Subject: PCN#26-05 Notification of Change for Lattice Standard Labels, Shipping Documents, and Update COO on Package Markings.

Lattice Semiconductor is providing this notification to inform customers of our intent to update the **Lattice standard labels** (inner and outer, see Appendices A and B), **shipping documents** (see Appendix C), and **package top marking** (see Appendix D) for all silicon products.

Appendix A - Detailed Description of Change(s): Lattice Standard Inner Box Label

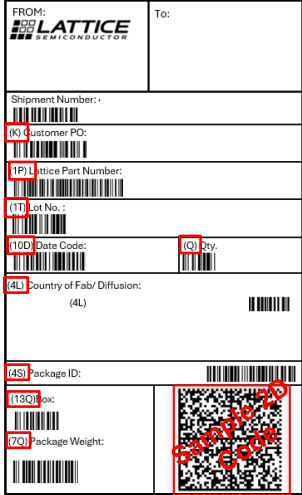
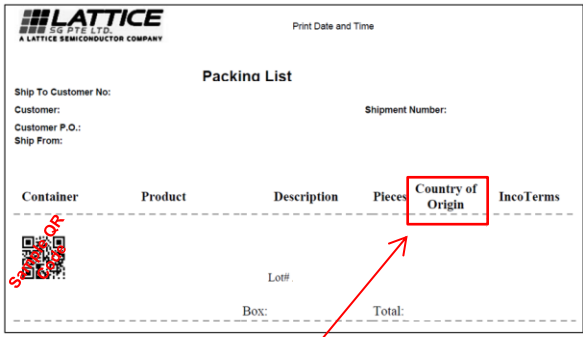
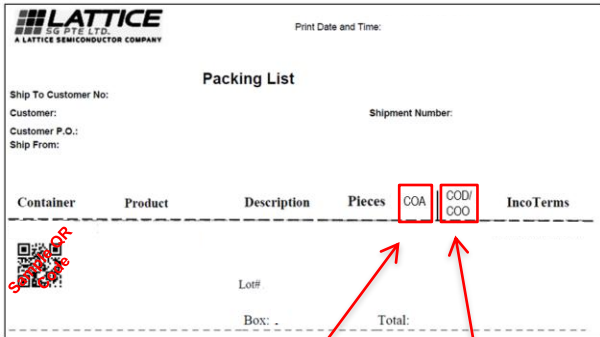
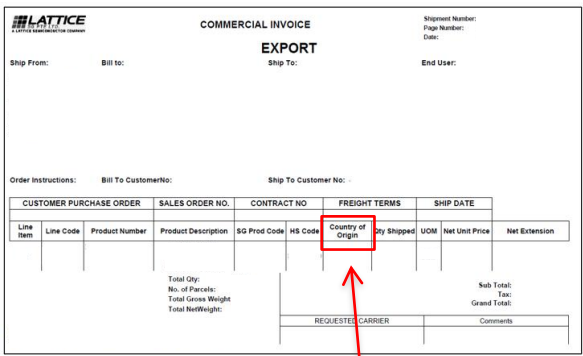
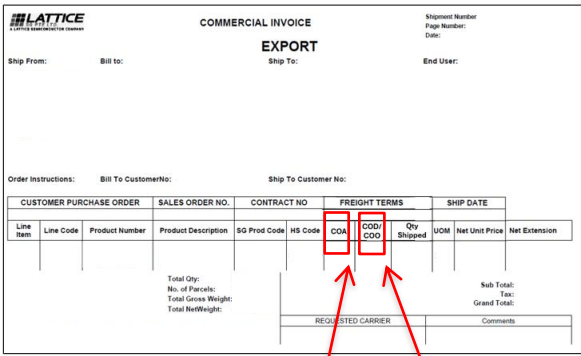
- 1) Data identifiers (e.g. 1P, 1T, 10D) are added to the human readable line and 1D (linear) barcodes to align with ECIA Industry Standard – EIGP 114.
- 2) 2D code changed to align with ECIA Industry Standard – EIGP 114 Format 06

Linear Barcode Output Information Format Product Alt Prod/ Customer P/N Lot No. Date Code Quantity Box Number 2D code Output Information Format Product AltProd Lot No. DateCode Qty BoxNo. Assembly In tracecode BagSealdate MSL	Linear Barcode Output Information Format (1P) Product Alt Prod: (1T) Lot No. (10D) Date Code (Q) Qty: (4S) Box No: Note on Alt Prod usage: • Add (2P) data identifier if there is a Alt Prod based on AI or MI, • Leave blank / no data identifier, if no Alt Prod requirement 2D code Output Information Format [>{RS}06{GS}1P(Product name){GS}2P(Alt Prod){GS}1T(Lot No){GS}10D(Date Code){GS}Q(Quantity){GS}4S(Box number){GS}4L(Country of Origin){GS}21L(Country of Assembly){GS}(Bag seal date){GS}(Moisture Sensitivity Level){RS}{EOT}

- 3) Updated Lattice logo and add HF, as applicable.

Appendix B - Detailed Description of Change(s): Outer Box Label.

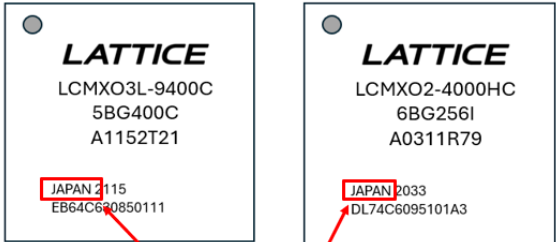
- 1) Data identifiers (e.g. 1P, 1T, 10D) are added to the human readable line and 1D (linear) barcodes to align with ECIA Industry Standard – EIGP 114.
- 2) 2D code changed to align with ECIA Industry Standard – EIGP 114 Format 06

Linear Barcode Output Information Format Customer PO (Box no) of (Total Box) Lattice Part Number. Reference # Lot Number Package Weight. Date Code Quantity Country of Origin 2D code Output Information Format ShipmentNumber@CustomerPO@LatticePartNumber @lotnumber@Datecode@Qty@COO@boxnumber	Linear Barcode Output Information Format (K) Customer PO (4L) Country of Origin (1P) Lattice Part Number (13Q) Box no of Total box (1T) Lot No. (7Q) Package Weight (10D) Date Code (Q) Quantity (4S) Package ID 2D code Output Information Format [>{RS}06{GS}{Shipment number}{GS}K{Customer PO}{GS}1P{Lattice Part Number}{GS}1T{Lot No}{GS}10D{Date Code}{GS}Q{Quantity}{GS}4L{Country of Origin}{GS}4S{Package ID}{GS}13Q{Box number of total box}{GS}7Q{Box Weight}{RS}{EOT}

Appendix C - Detailed Description of Change(s): Shipping Documents.

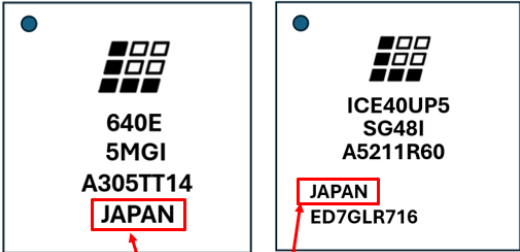
From	To
Packing List  Country of Origin	Packing List  COA COO/COD
Commercial Invoice  Country of Origin	Commercial Invoice  COA COO/COD
